**Re: Alectra Utilities Corporation (Alectra Utilities)  
Application for 2020 Electricity Distribution Rates  
OEB Staff Interrogatories  
Ontario Energy Board (OEB) File Number: EB-2019-0018**

**OEB Staff Interrogatories**  
**2020 Electricity Distribution Rates Application**  
**Alectra Utilities Corporation (Alectra Utilities)**  
**EB-2019-0018**  
**August 16, 2019**

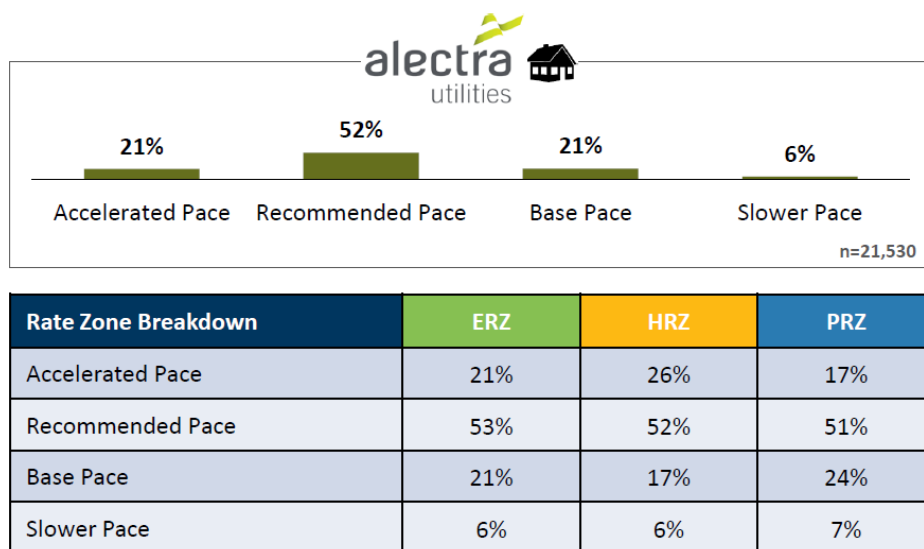
Although the aggregate sum of customers preferring the accelerated or recommended pace is 73%, the number of customers preferring the accelerated pace is only 21%. The majority of customers prefer the recommended pace. OEB staff notes that, by Alectra Utilities' methodology, the aggregate sum of recommended pace or base pace is also 73%.

- Given that the majority of customers chose the recommended pace, please explain why Alectra Utilities elected to proceed with the accelerated pace.
- Given that 73% of customers also prefer the recommended or base pace, did Alectra Utilities consider proceeding with the base pace? If not, why not, and how is this different from the scenario where Alectra Utilities considered the accelerated pace?

Figure 24 Primary XLPE Cables Age Distribution

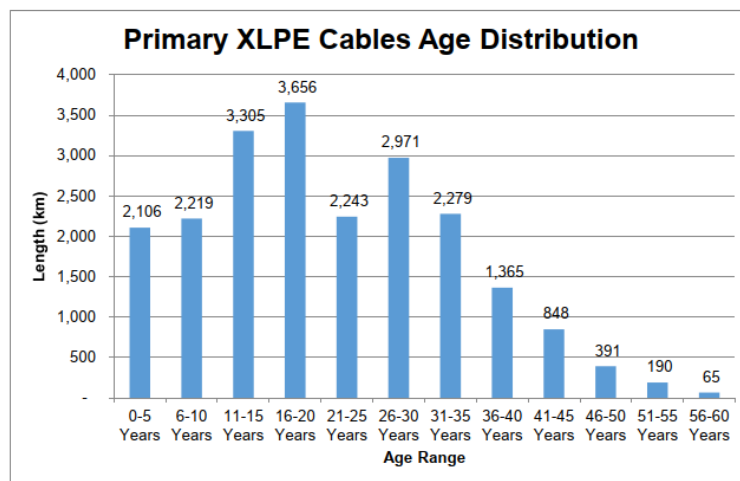
- a) Please confirm that XLPE cables were first used in the late 1960's<sup>3</sup> (i.e., the assets over 50 years of age do not represent XLPE cables).
  - i. If yes, please explain why Figure 5.0 - 4 contains XLPE cabled labeled as over 50 years of age and provide a revised figure with correct labels.
- b) Has Alectra Utilities analyzed the actual lifespan of its underground cable assets vs. expected lifespan?
  - i. If yes, please provide the results of the analysis.
- c) Are underground cables ever treated as run to fail, or are they always replaced at a given age?
- d) Does Alectra Utilities replace failed cable segments without replacing adjacent segments? I.e. if one phase of a circuit needs to be replaced on an emergency basis, are all three phases replaced at that time?

Ref: Exhibit 4, Tab 1, Schedule 1, Appendix C, Page 43

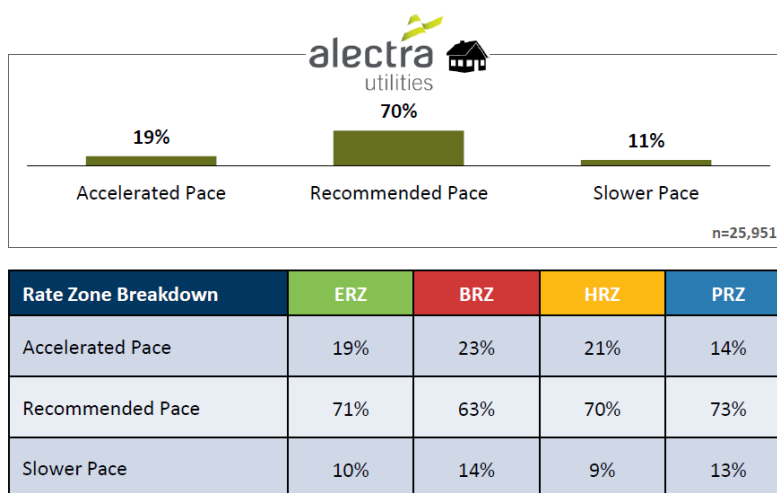
Please explain why Guelph rate zone customers were not consulted on overhead system renewals.

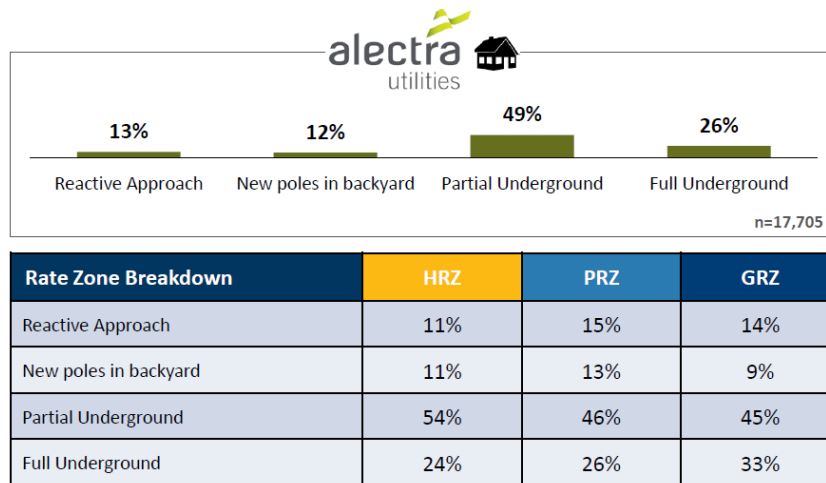
- a) The table above presents the customer preferences taken from a sample of all of Alectra Utilities' customers, not just customers serviced through rear lots. Has Alectra Utilities consulted directly with the customers affected by these projects? If so, what kind of customer engagement efforts has Alectra Utilities undertaken?
- b) Please explain why Alectra Utilities chose the option of full underground conversion despite a majority of customers choosing the partial underground option.

**Figure 5.2.3 - 9: Customer Hours of Interruption Due to Defective Equipment at Alectra Utilities from 2014 to 2018**

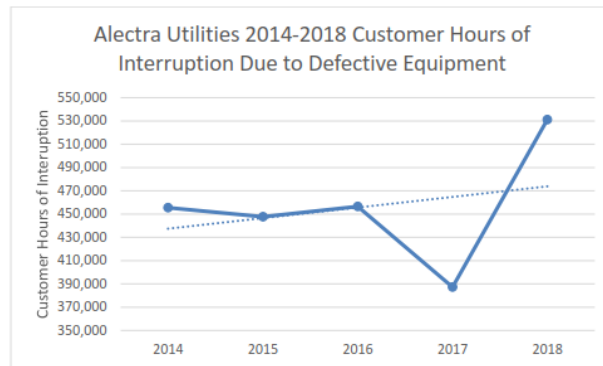
- Please provide a graph of the number of interruptions by defective equipment by year (for the period of 2014-2018).
- Please provide a graph of the number of interruptions by defective equipment by asset category (for the period of 2014-2018).

Figure 22 Concrete Poles Age Distribution

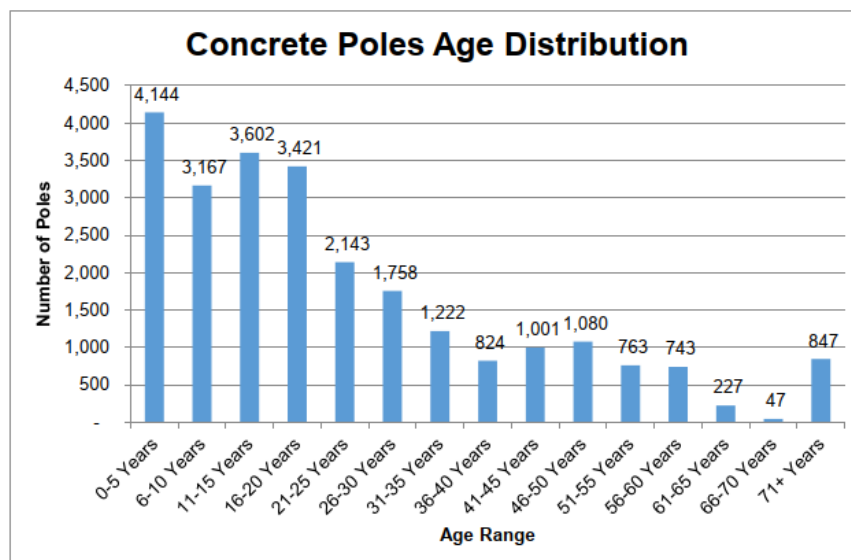
- Please provide a revised Figure 22 showing the number of poles over 80 years of age.
- Please explain whether a field inspection multiplier is redundant, given that a post-field inspection condition rating should reflect an assessment of major degradation or imminent failure.

Figure 17 Overhead Switches Health Index Distribution

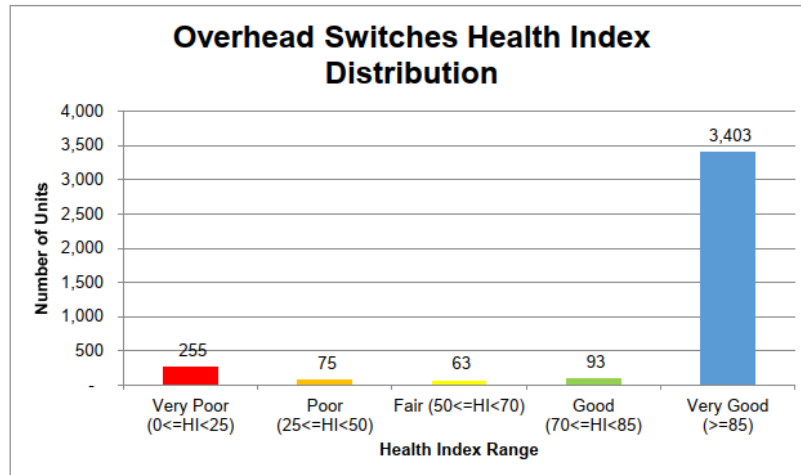
- Given that the Health Index for overhead switches is calculated using only age as an input, and 140 switches are beyond EUL, why have 255 switches been rated as having a Very Poor Health Index?
- Please show how the Health Index results in Figure 17 were calculated.

Figure 34 Circuit Breakers Health Index Distribution

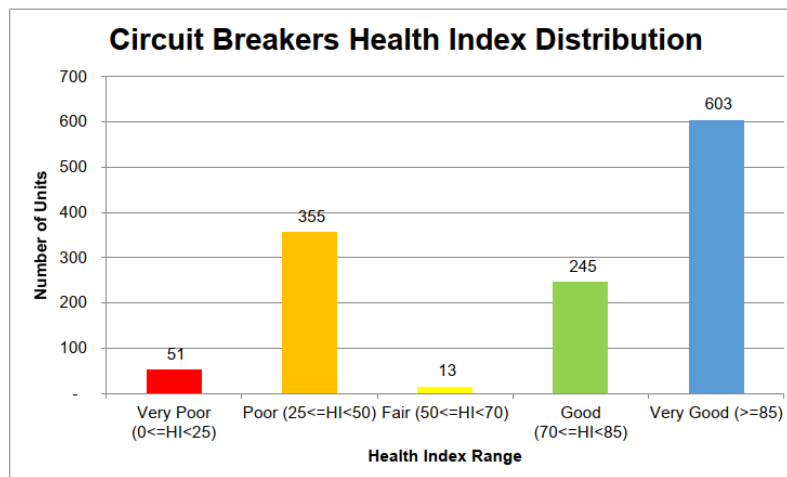
- a) What is the primary input driving the Poor Health Index rating for the 355 circuit breakers shown in Figure 34?
- b) Please provide a revision of Figure 34 without the obsolescence multiplier applied.

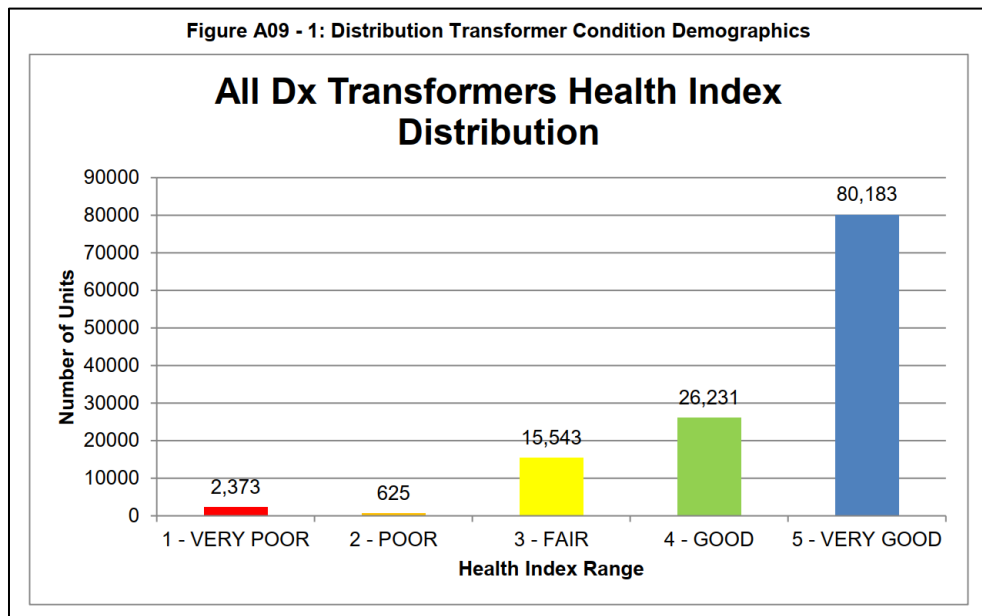
- a) How many poletop transformers does Alectra Utilities plan to replace prior to failure during forecast years 2020 - 2024?
- b) What is the total cost of these predictive replacements?
